CITY OF ALBUQUERQUE

Re: Hotel Chaco
2000 Bellamah Ave. NW
30-Day Temporary Certificate of Occupancy- Transportation Development
Architect's Stamp dated 9-4-14 (J13D066)
Certification dated 4-12-17

RE: TCL for Final C.O.
Hotel Chaco-Heritage Hotels and Resorts
2000 Bellamah Ave. NW, Albuquerque, NM 87104
Zone: J-13

AS1.101

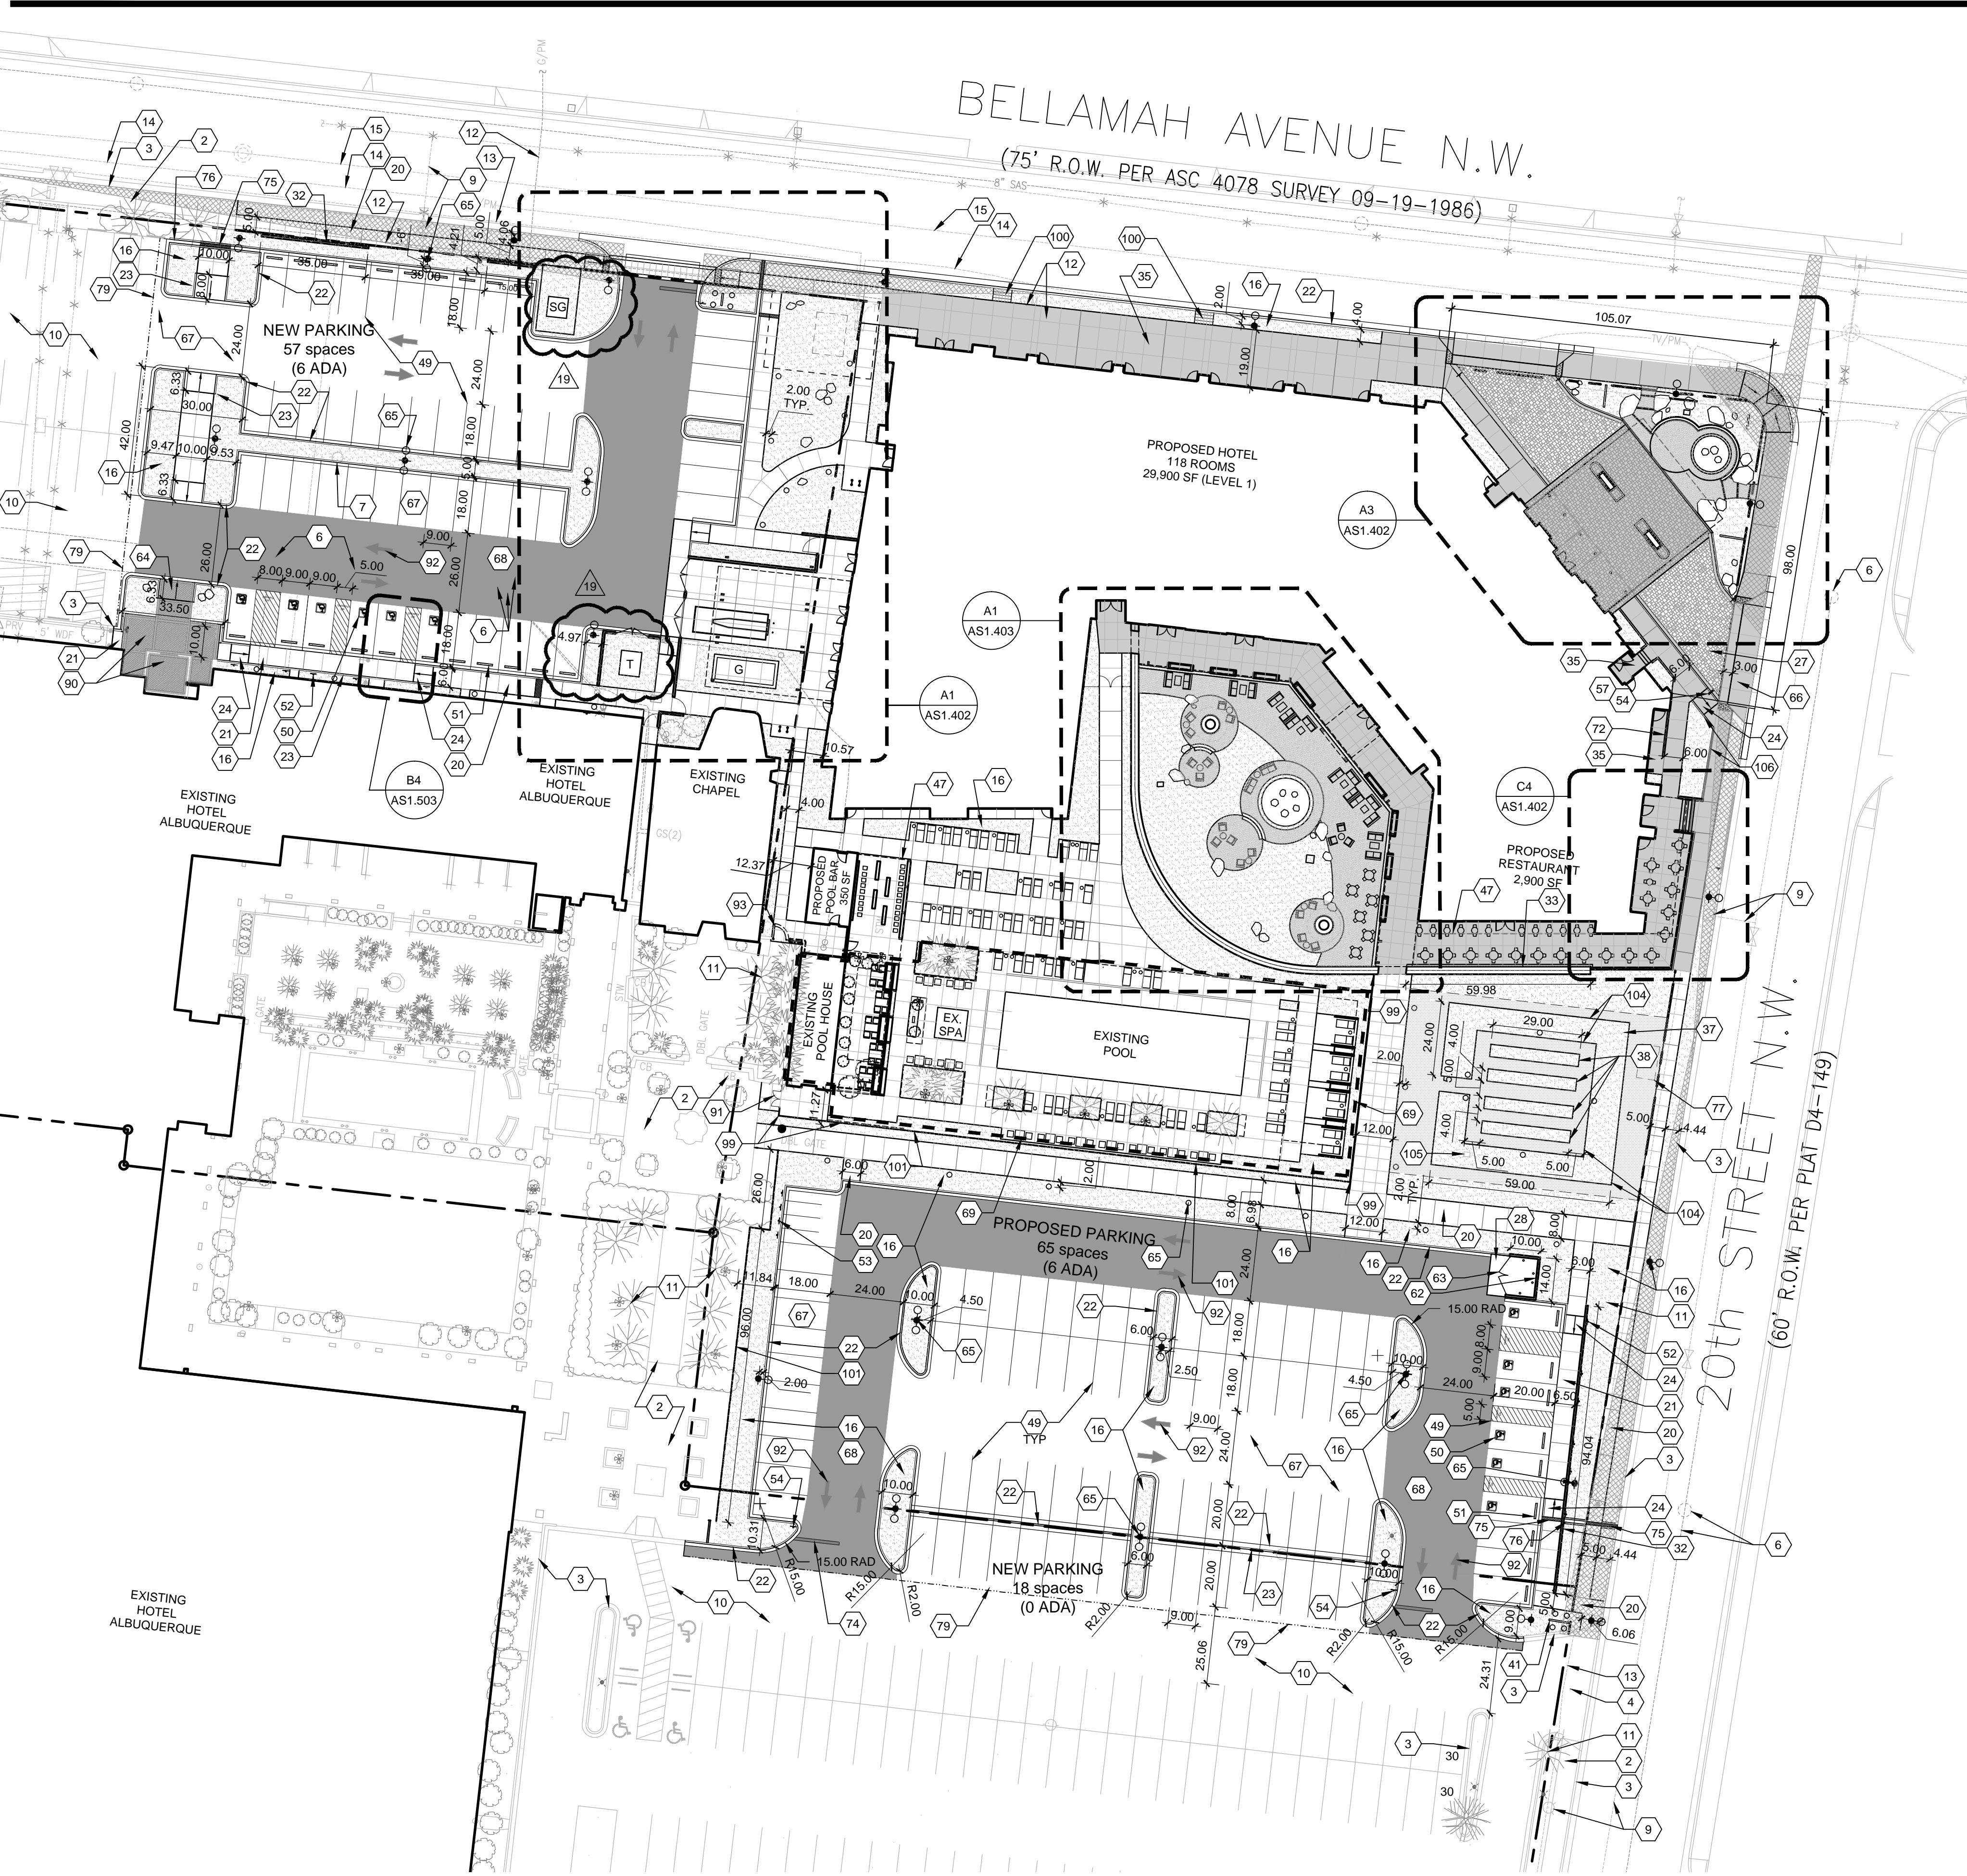
1. In the parking lot on the north west side of the site the bottom of the ADA sign is required to be 60 inches minimum above the ground or parking surface. (ANSI 502.7)
2. The ADA accessible parking sign must have the required language per 66-7-352.4C NMSA 1978 "Violators Are Subject to a Fine and/or Towing." Please call out detail and location of HC signs.
